IRON HAMMER AT CENTRETECH - SITE PLAN AMENDMENT

SITE PLAN AMENDMENT	IRON HAMMER AT CENTRETECH 279 LAREDO STREET AURORA, CO JESSE DONOVAN, P.E. 720-504-8629
---------------------	--

REVISION NUMBER	REVISION DESCRIPTION	DATE
00	FIRST SUBMITTAL	09/21/2023
01	SECOND SUBMITTAL	02/05/2024
02	THIRD SUBMITTAL	07/23/2024

SITE PLAN

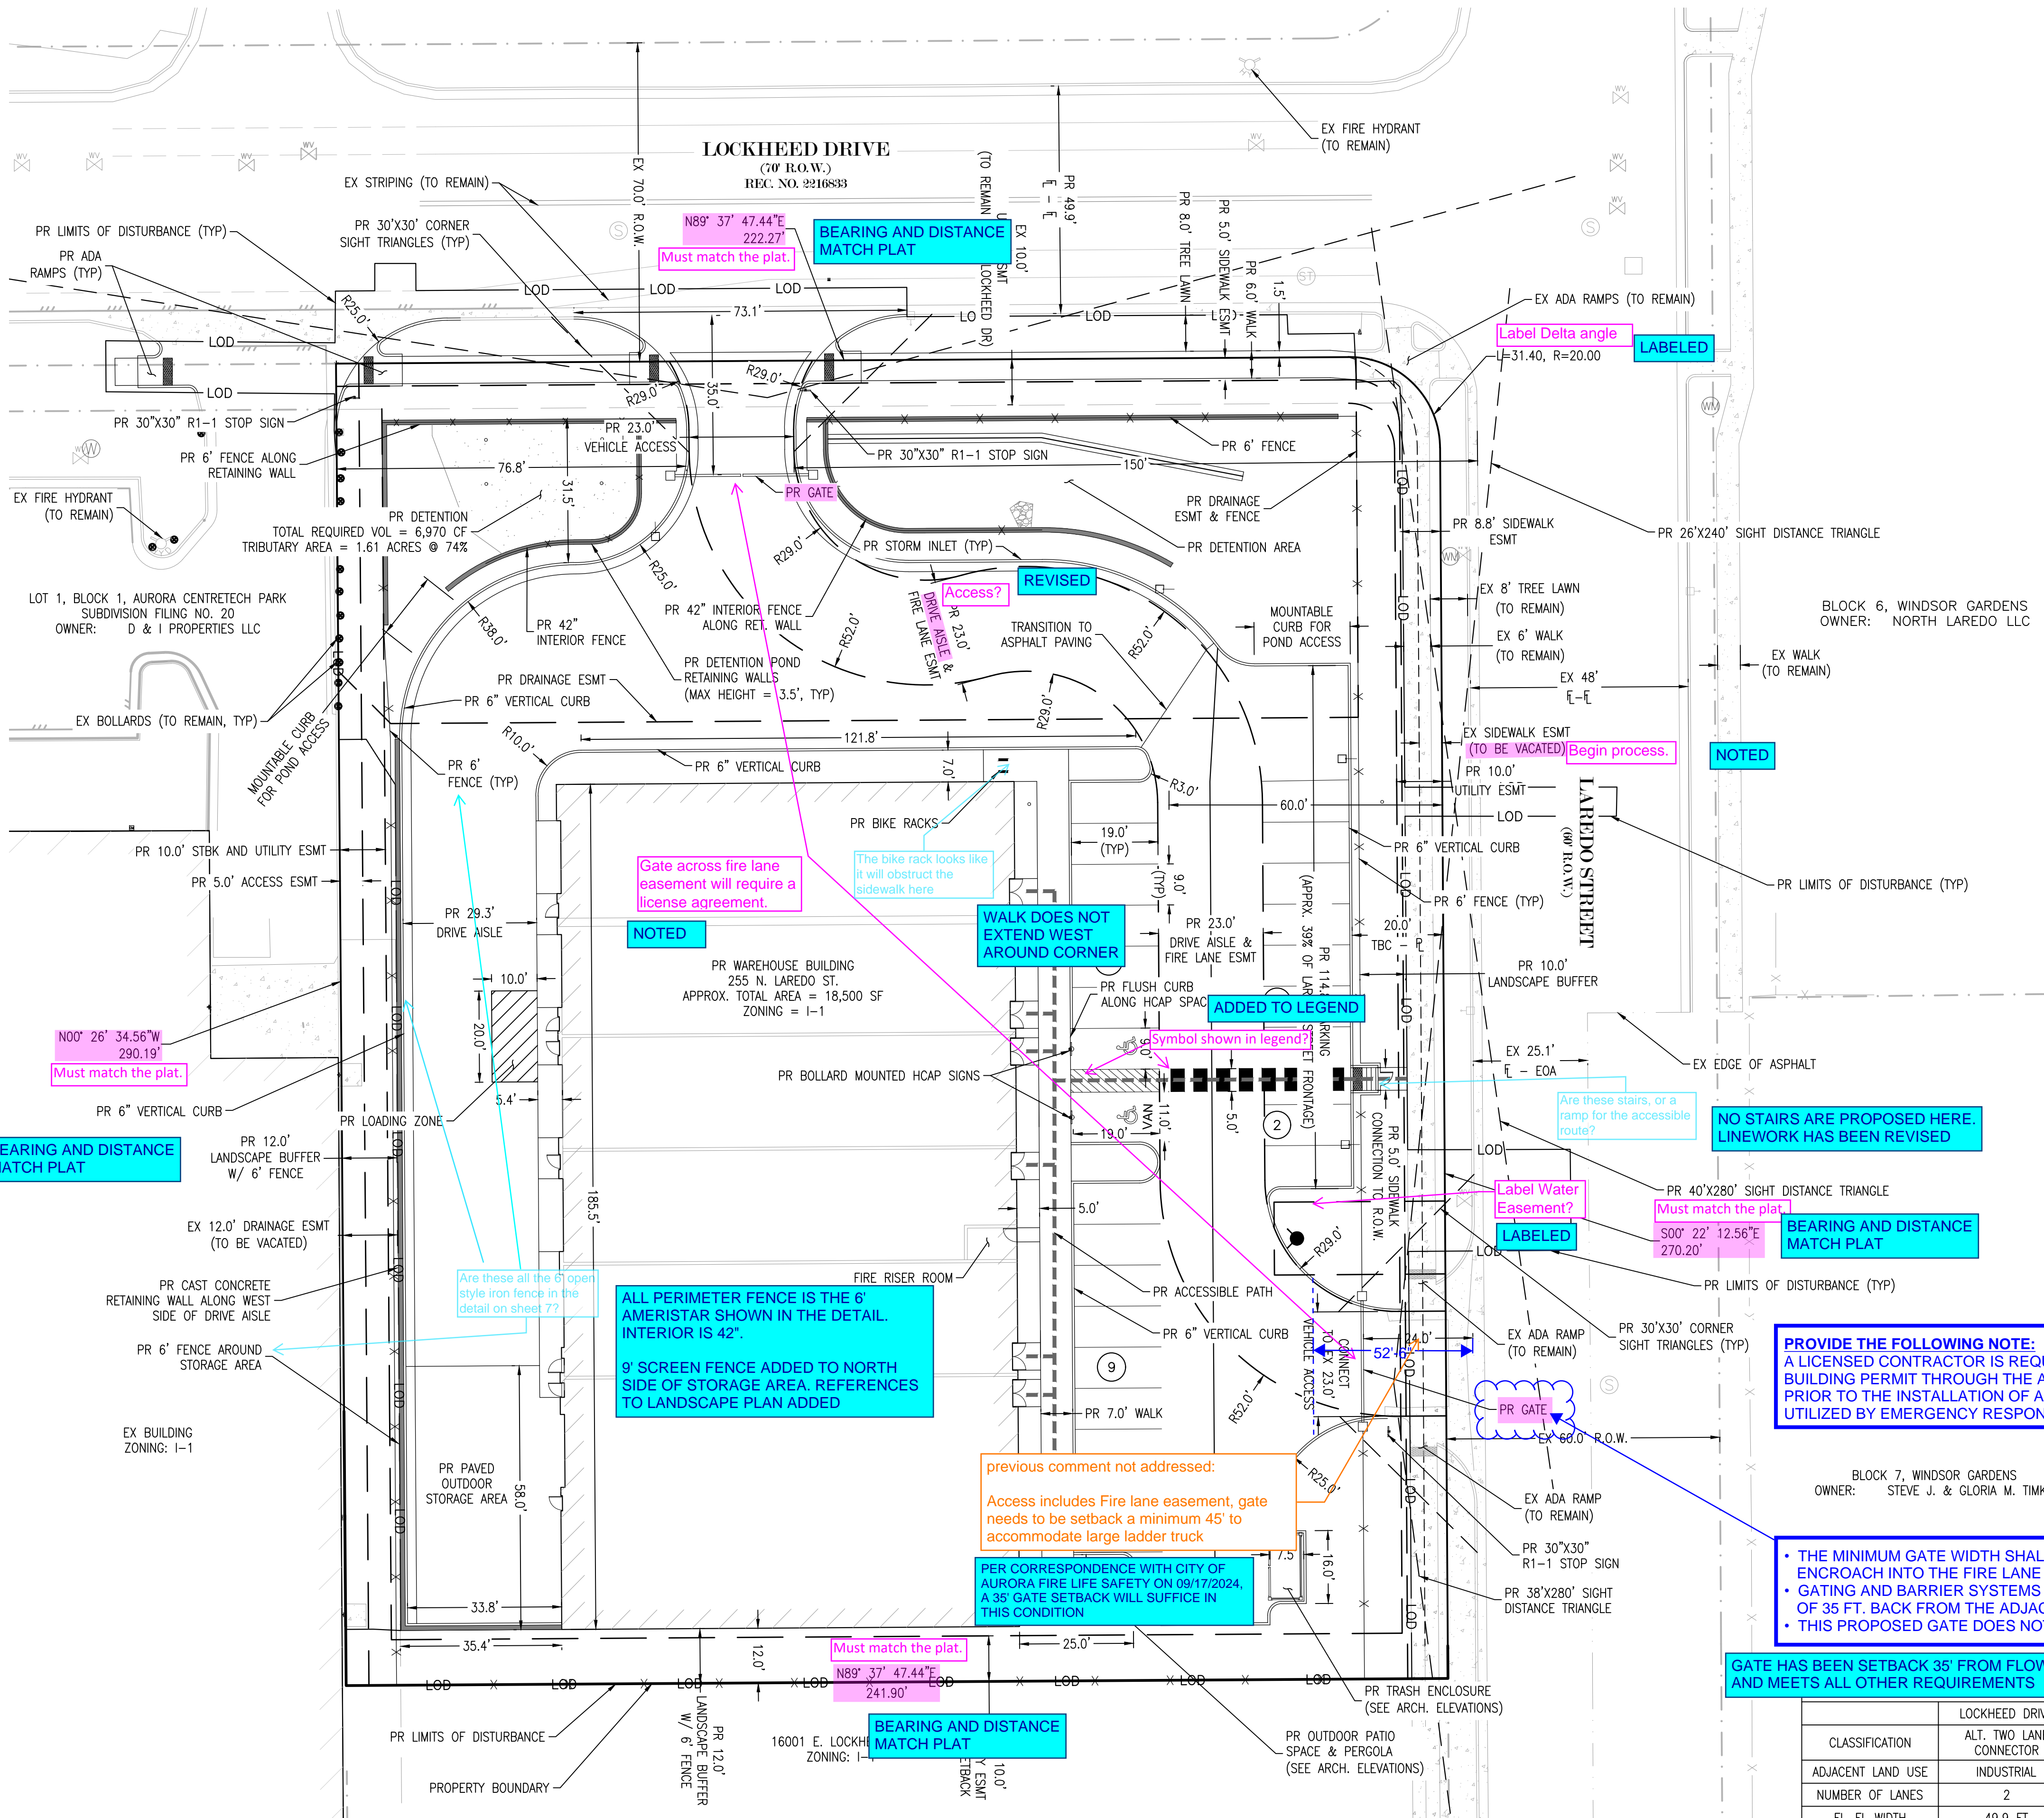
PROVIDE THE FOLLOWING NOTE:
A LICENSED CONTRACTOR IS REQUIRED TO OBTAIN A VALID BUILDING PERMIT THROUGH THE AURORA BUILDING DIVISION PRIOR TO THE INSTALLATION OF ANY GATING SYSTEM UTILIZED BY EMERGENCY RESPONDERS TO ENTER THE SITE.

- THE MINIMUM GATE WIDTH SHALL BE 23 FEET AND SHALL NOT ENCRACH INTO THE FIRE LANE EASEMENT IN THE OPEN POSITION.
- GATING AND BARRIER SYSTEMS MUST BE LOCATED A MINIMUM OF 35 FT. BACK FROM THE ADJACENT STREET FLOW LINE.
- THIS PROPOSED GATE DOES NOT MEET THE REQUIREMENT.

LABEL THE TYPE OF GATING SYSTEM BEING INSTALLED ON THE SITE PLAN IN THE FOLLOWING MANNER:
• 23' AUTOMATIC SLIDING GATE WITH APPROVED SIREN OPERATED SYSTEM, KNOX KEY SWITCH AND MANUAL RELEASE.
• 23' MANUAL SWINGING GATE WITH APPROVED KNOX HARDWARE.
• 23' MANUAL SLIDING GATE WITH APPROVED KNOX HARDWARE.
• 23' ELECTRICAL SLIDING GATE WITH APPROVED KNOX HARDWARE.

GATE HAS BEEN SETBACK 35' FROM FLOW LINE AND MEETS ALL OTHER REQUIREMENTS

BOTH GATES HAVE BEEN LABELED ACCORDINGLY

LANDSCAPE PLAN

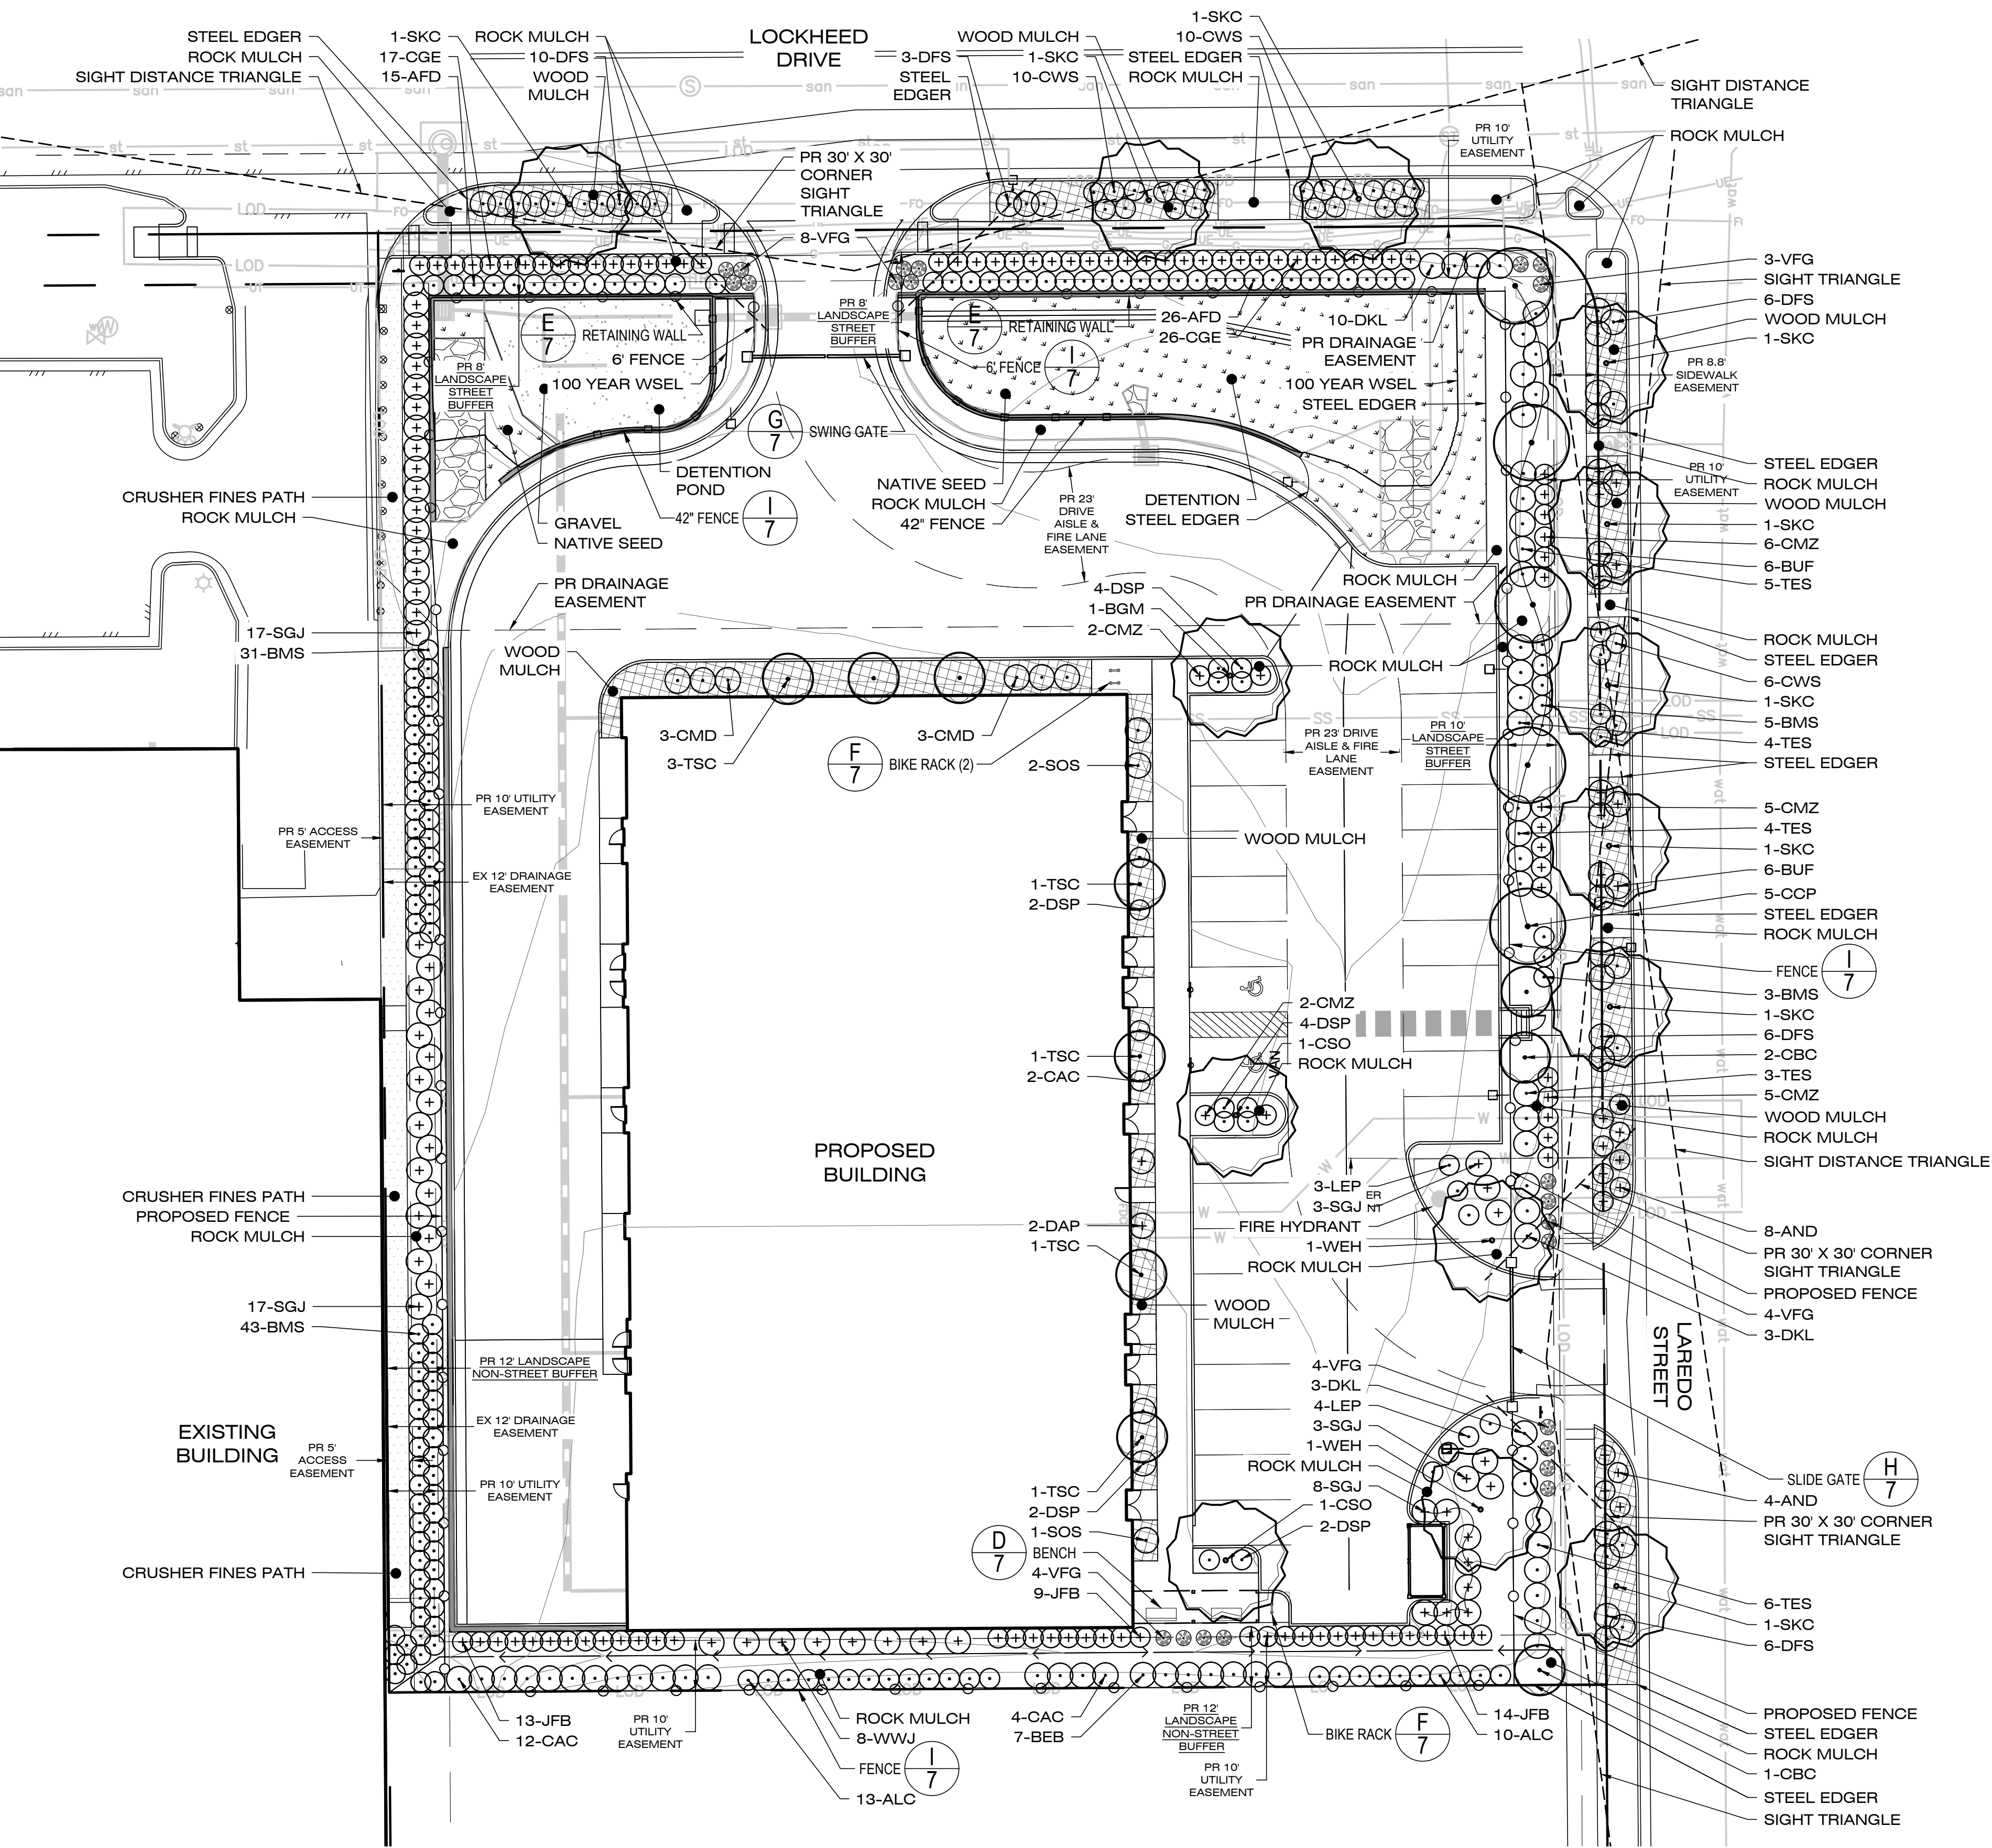
- (SEE SHEET L1 FOR FULL PLANT LIST)
- DECIDUOUS SHADE TREES
 - ORNAMENTAL TREES
 - DECIDUOUS SHRUBS
 - EVERGREEN SHRUBS
 - ORNAMENTAL GRASSES
 - LARGE PERENNIALS
 - DRYLAND NATIVE SEED
 - WOOD MULCH
 - MAINTENANCE PATH
 - 6' IRON FENCE
 - 42" IRON FENCE FENCE
 - 6' MASONRY WALL

ODG RESPONSE: A 6' HEIGHT MASONRY WALL IS NO LONGER BEING PROPOSED. WE HAVE CORRECTED THE LEGEND TO SHOW RETAINING WALL LOCATIONS AND FENCE LOCATIONS AND HEIGHTS.

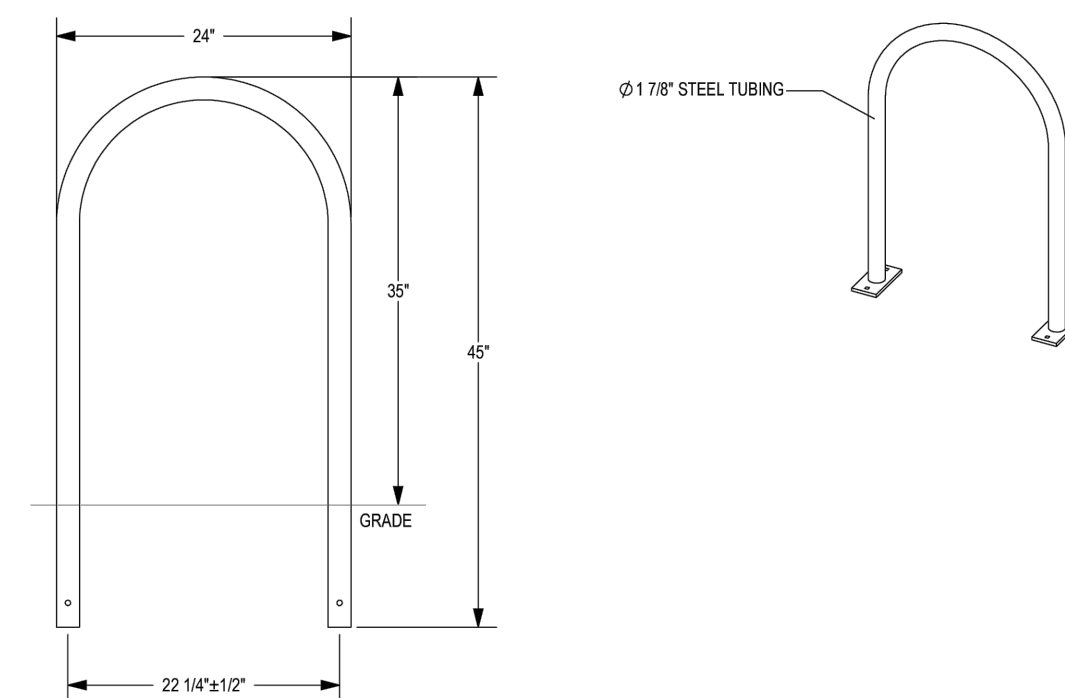
type of fence or wall? _____

ODG RESPONSE: THIS IS FENCE, SEE
DETAIL J, SHEET 7. THE DETAIL HAS
BEEN CLARIFIED TO SHOW THAT THE
FENCE IS EITHER 6' HEIGHT AS PART OF
THE LANDSCAPE BUFFERS ALONG
LOCKHEED AND LAREDO, OR 42" HEIGHT
AS FALL PROTECTION AROUND THE
DETENTION POND. SEE LANDSCAPE
PLAN SHEET FOR HEIGHTS.
